**SOILS AND GEOLOGY STUDY
RETREAT AT TIMBERRIDGE FILING NO. 4
PARCEL NO. 52220-00-023
EL PASO COUNTY, COLORADO**

December 21, 2023
Revised June 17, 2024

GEOLOGY / ENGINEERING MAP
 RETREAT AT TIMBERRIDGE FIL. NO. 4
 EL PASO COUNTY, CO
 TIMBERRIDGE DEVELOPMENT GROUP, LLC

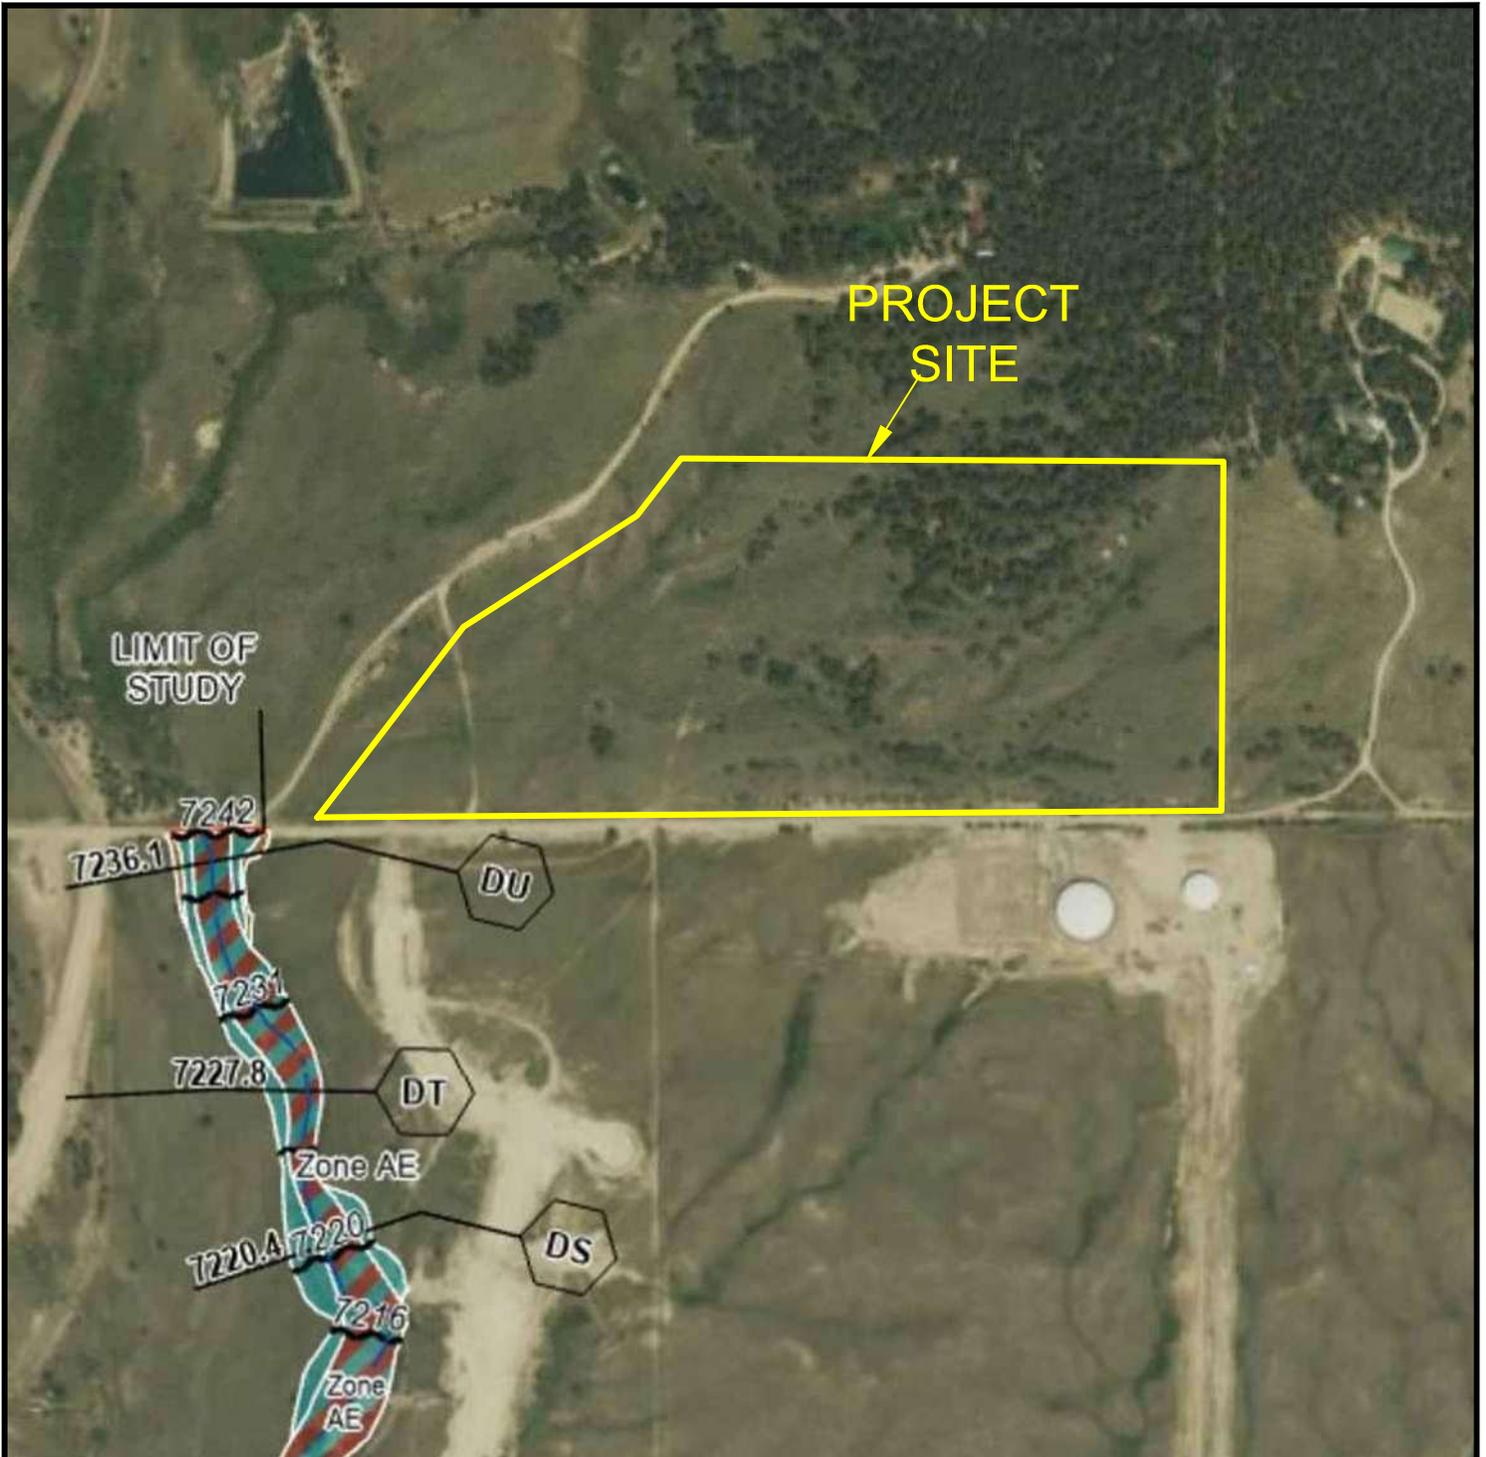
Unresolved. See comment from v2. Please elaborate, I'm not seeing how an inlet at approx. el. 7260 is going to mitigate potential groundwater issues within the pond (el. 7250 - 7256).

The northern side of the proposed embankment for the Extended Detention Basin (EDB) is located in a potential seasonal shallow groundwater area as indicated on the Geology/Engineering Geology Map, Figure 6. Areas receiving fill may require stabilization with rock or geogrid if shallow groundwater conditions are encountered. A private storm sewer that discharges to the EDB is proposed along a section of Nature Refuge Way and through the drainage easement on Lot 1. A vane grate inlet that is connected to the storm sewer is proposed in the potential seasonal shallow groundwater area on the northeastern side of the proposed embankment.

The northern side of the proposed embankment for the EDB is located in a potential seasonal shallow groundwater area as indicated on the Geology/Engineering Geology Map, Figure 6. Based on the soils types and the gradual existing slopes near the EDB location lining of the EDB is not necessary. Any areas to receive fill should have all topsoil, organic material or debris removed. Prior to fill placement Entech should observe the subgrade. Fill must be properly benched and compacted to minimize potentially unstable conditions in slope areas. Fill slopes should be 3:1 or flatter. The subgrade should be scarified and moisture conditioned to within 2% of optimum moisture content and compacted to a minimum of 95% of its maximum Modified Proctor Dry Density, ASTM D-1557, prior to placing new fill. Areas receiving fill may require stabilization with rock or fabric if shallow groundwater conditions are encountered.
